**QUALITY CONTROL AND QUALITY ASSURANCE REVIEW
FORT CALHOUN NUCLEAR FACILITY
GEOTECHNICAL INVESTIGATION AND TESTING PROGRAM**

Following is Report No. 1 for my Quality Assurance Reviews performed during the week of September 12 to September 16, 2011. This report also includes results of calibration of field and laboratory equipment furnished by the geotechnical contractor, Thiele Geotech, Inc., Omaha, NE.

QA/QC Report 1 - Geotechnical Investigation - Fort Calhoun Nuclear Facility
 September, 2011
 McCook Geotechnical Engineering, Consultant to HDR

SPT Hole B-2 and CPT Hole C-1

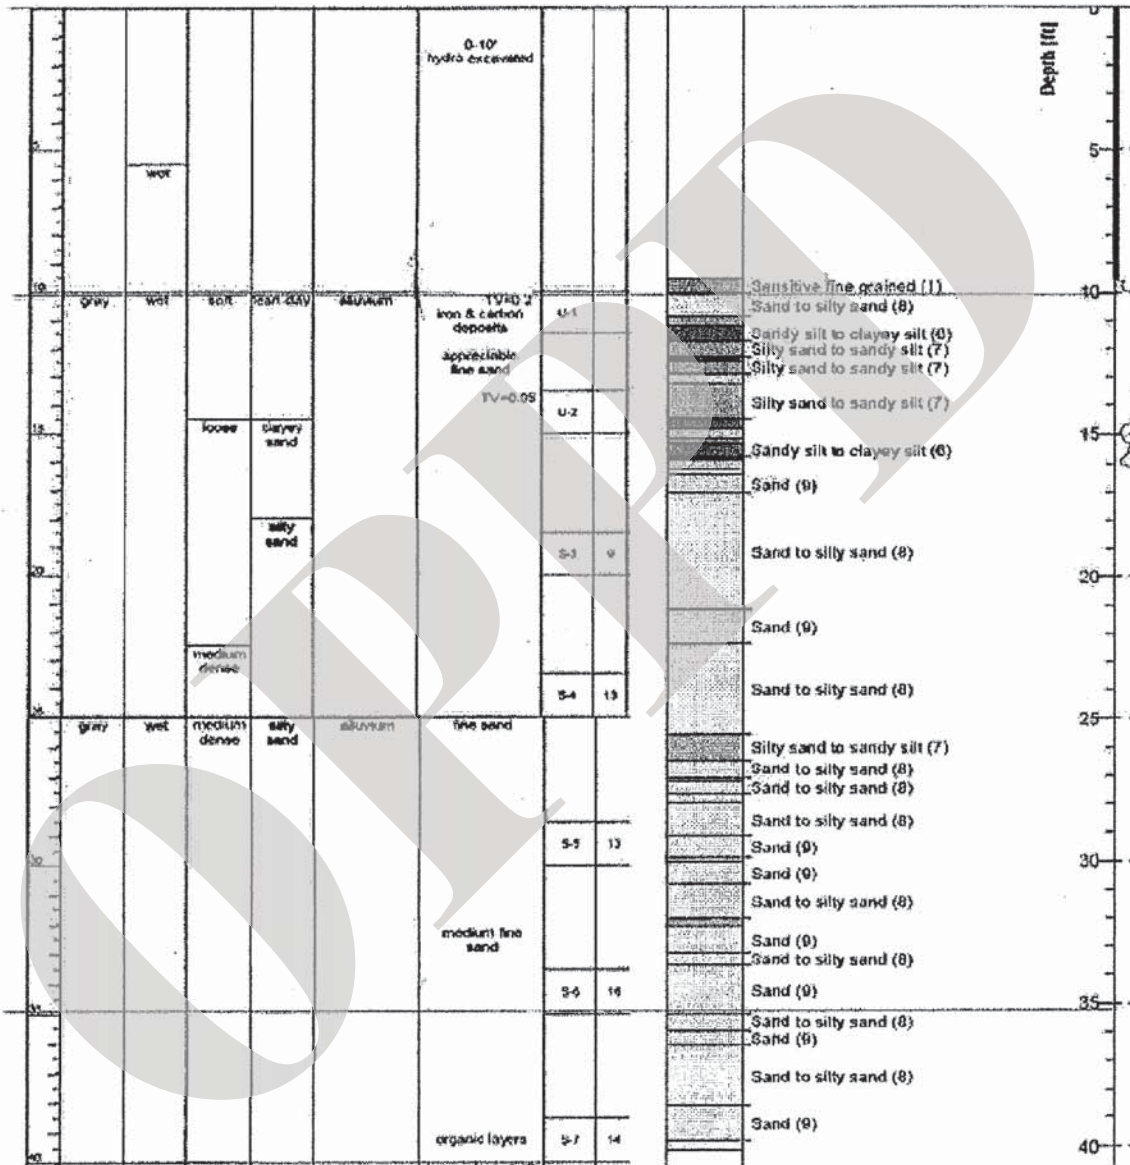
13. The SPT data and the CPT data correlated well. For example, refer to the following page for an illustration. The example shows B-2 overlain with CPT-1, which are immediately next to one another.
